Proposed Changes to SpaceWire Physical Layer

Shaune S. Allen

NASA Goddard Space Flight Center

Changes to SpW Cable Construction

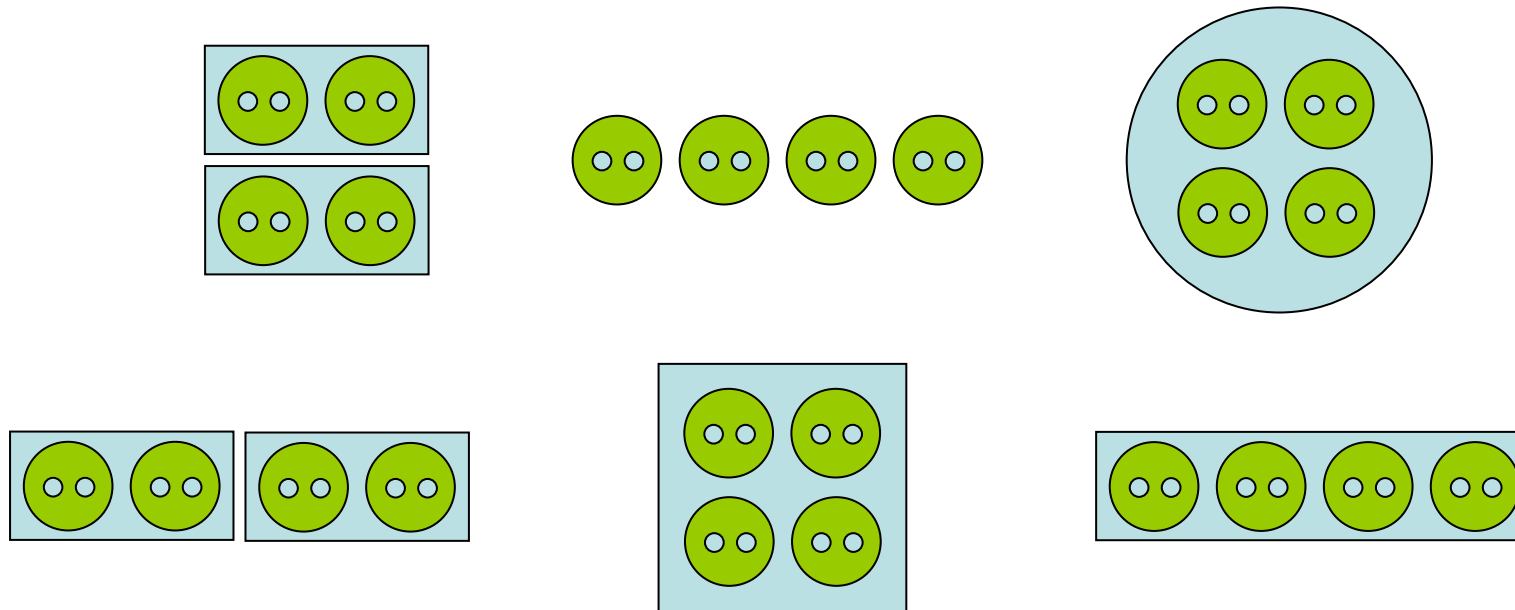
- **Add 26 AWG SpW cable to the standard**
 - Make appropriate additions to Detail Specification 3902/003
 - When necessary add a separate statement regarding the 26 AWG version
- **Alternative create a chart which lists the critical parameters**
